I-85 SEWER EXTENSION  
CONTRACT 1B – COLLECTIONS

ADDENDUM NO. 6

January 10, 2024

Gaffney Board of Public Works  
I-85 Sewer Extension  
Contract 1B- Collections Broad River  
WWTP to Bear Den SPS

**BLACKSBURG HWY  
BRIDGE PIPE SUPPORT  
DETAILS**

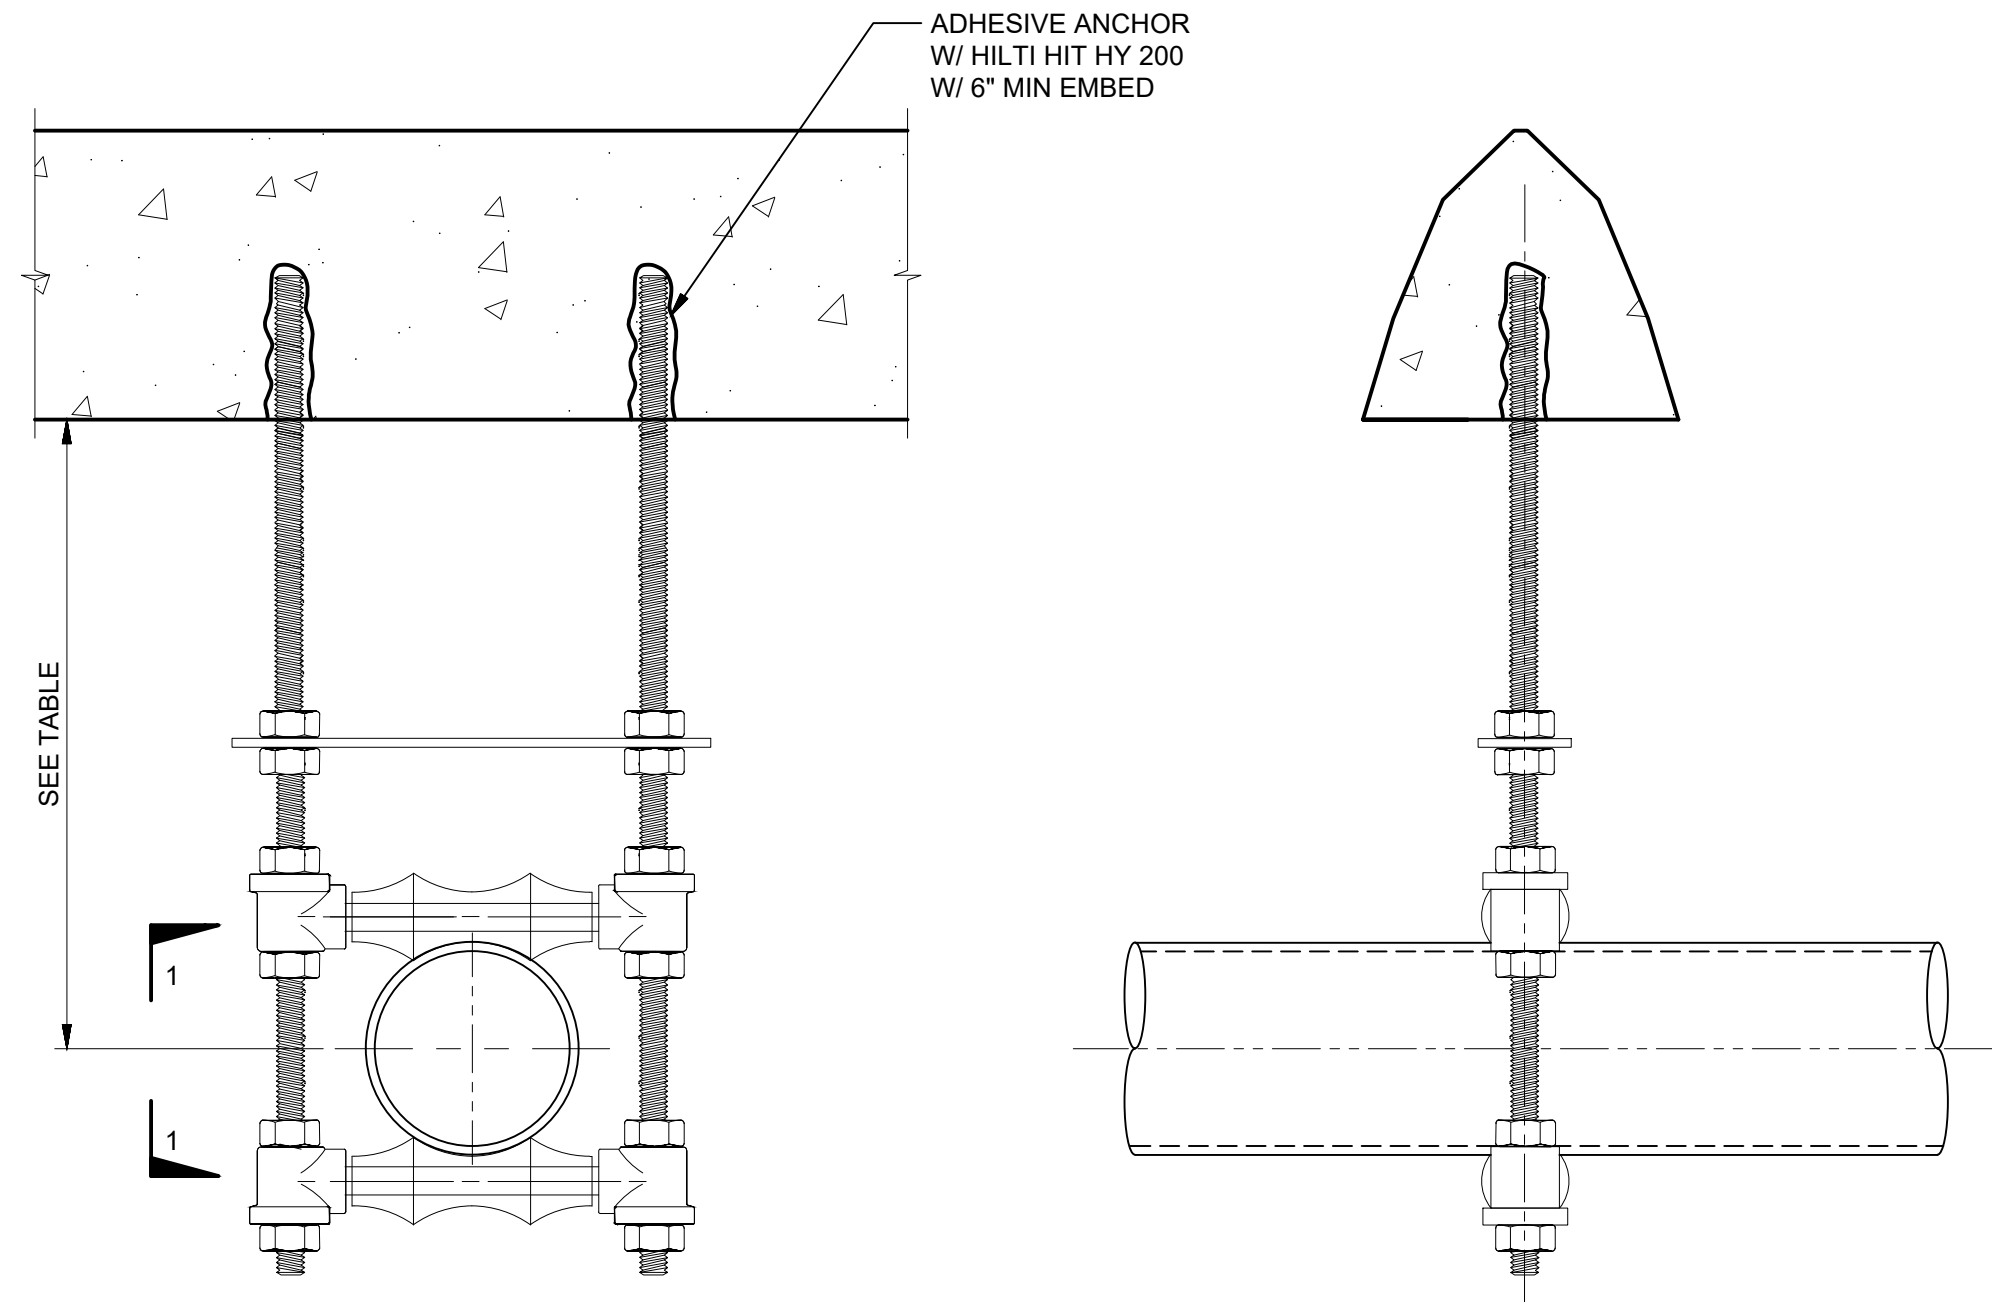
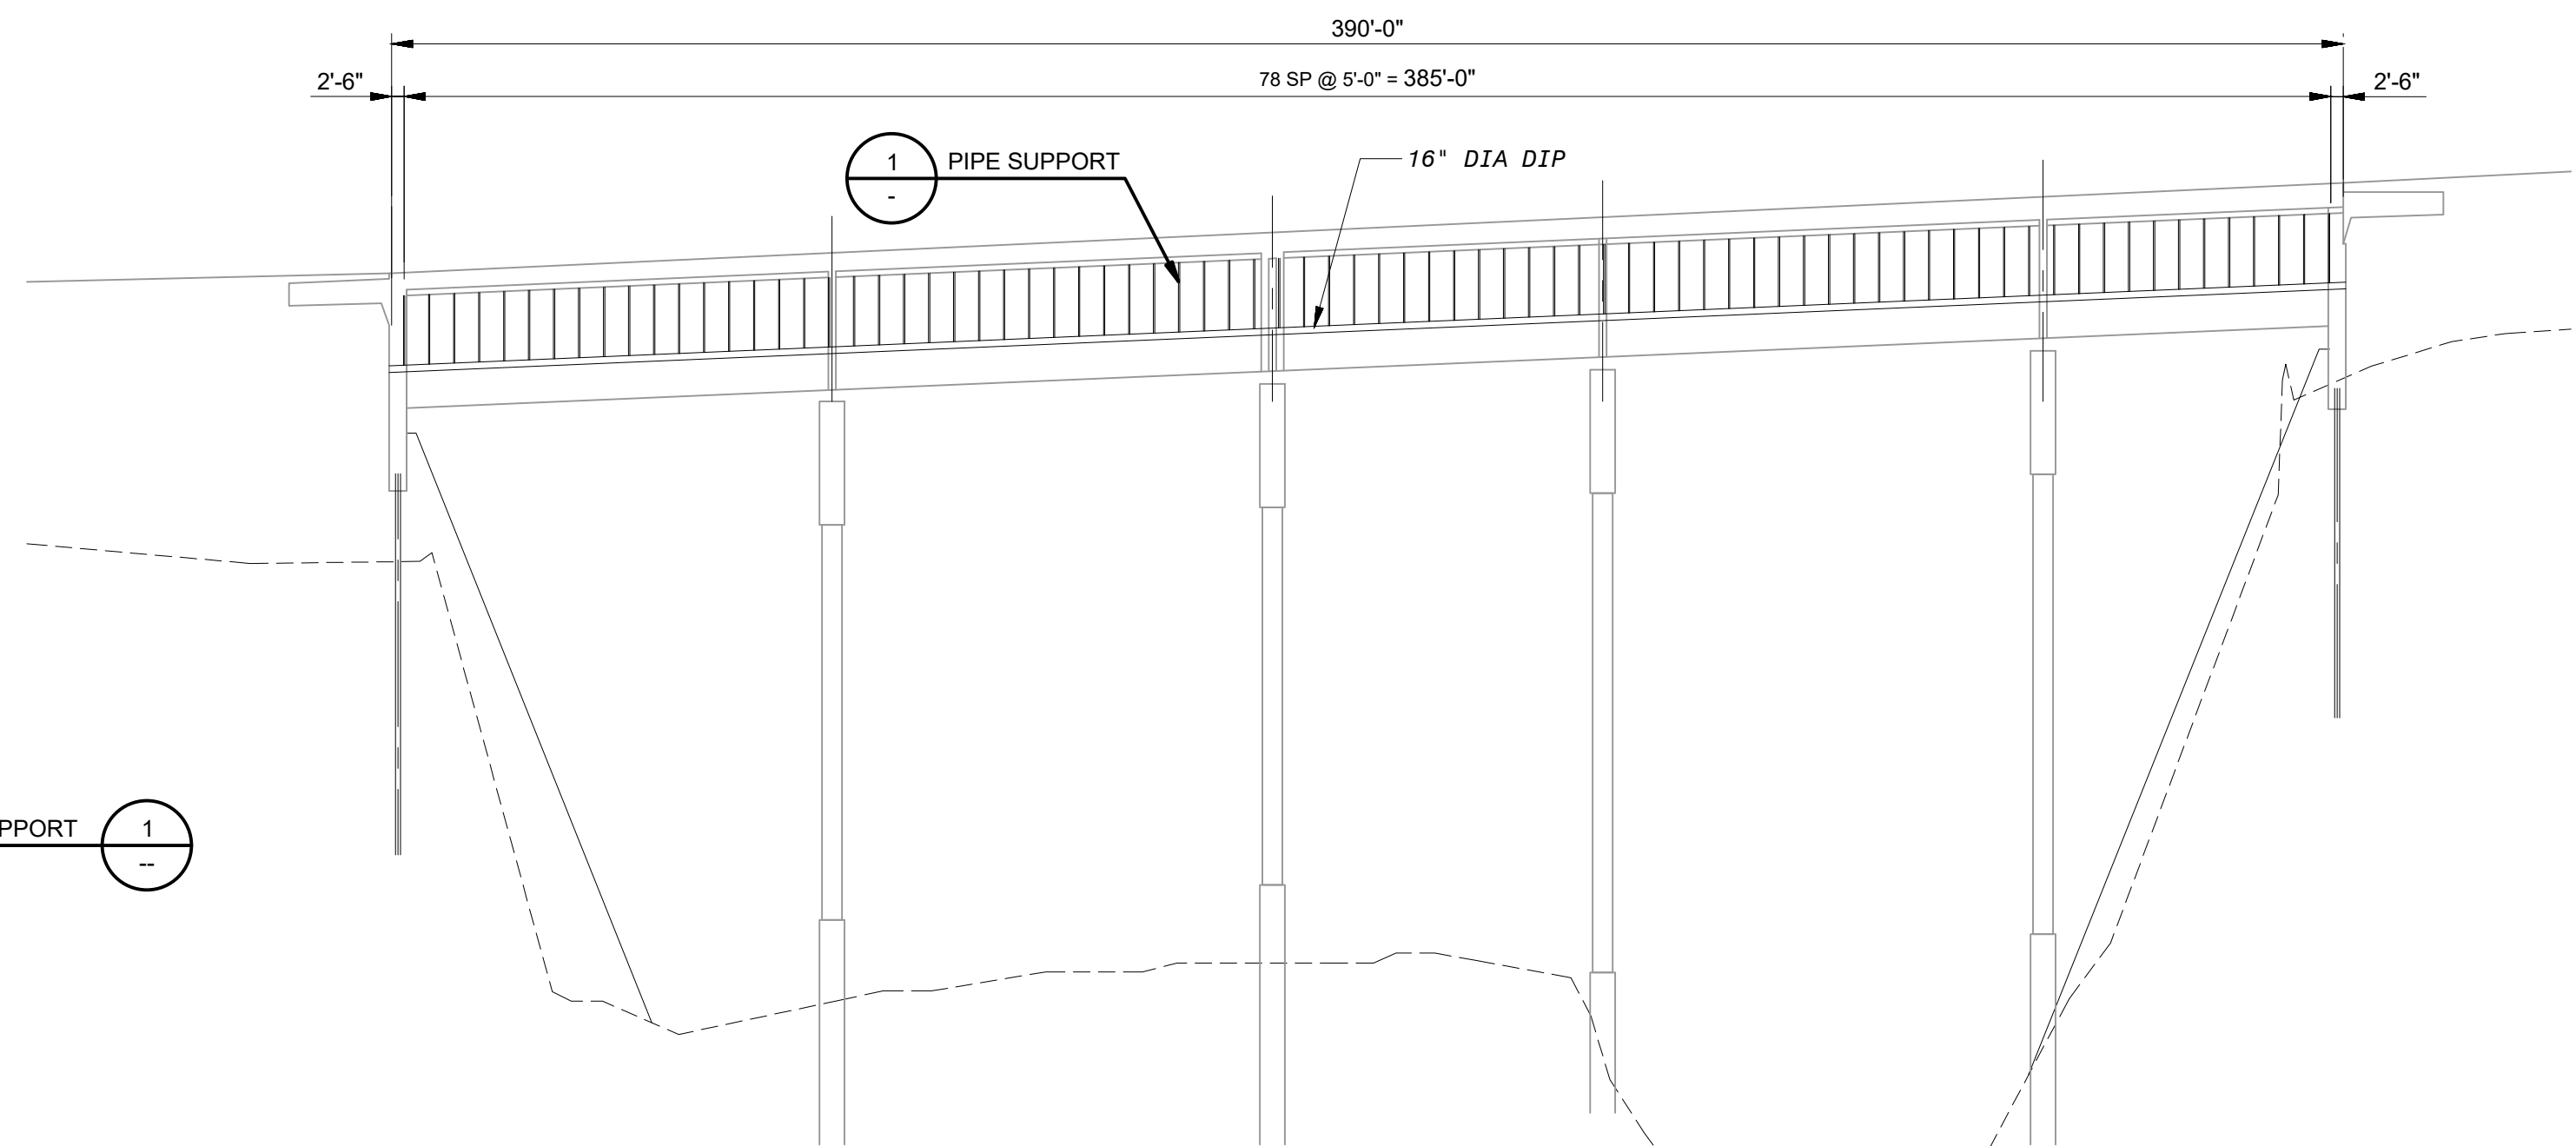
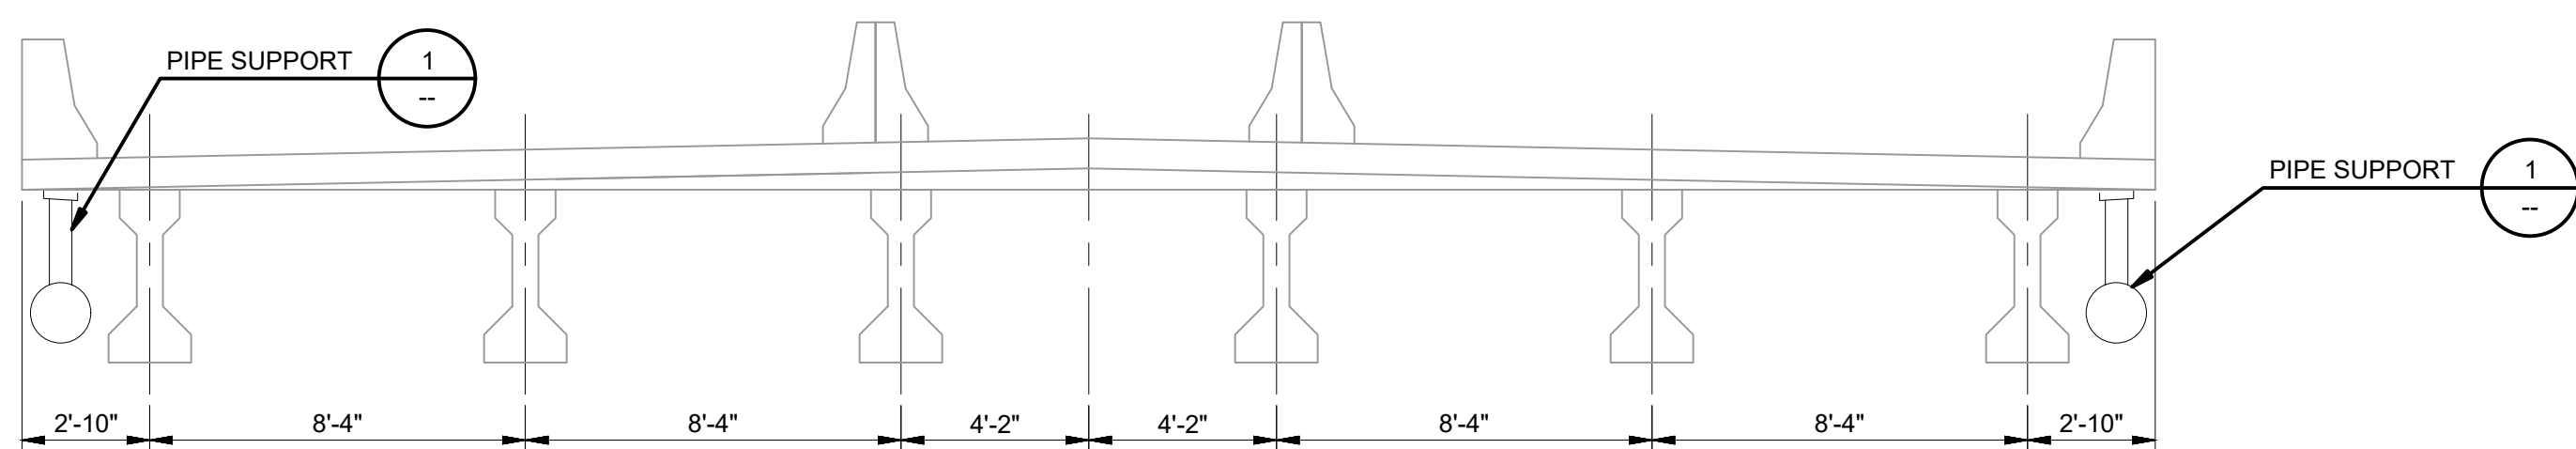
56	S-00-001	STANDARD STRUCTURAL NOTES
57	S-01-101A	HWY 329 BRIDGE PIPE SUPPORT DETAILS
58	S-01-102A	BLACKSBURG HWY BRIDGE PIPE SUPPORT DETAILS

- i. Insert the attached new sheets C-02-111A and C-02-112A for Segment 2 Alternative 1 and the new sheets C-03-114A and C-03-115A for Segment 3 Alternative 2 after sheet C-03-120.
- ii. Insert the attached new sheets S-00-001, S-01-101A, and S-01-102A for the Alternatives after sheet C-99-006.
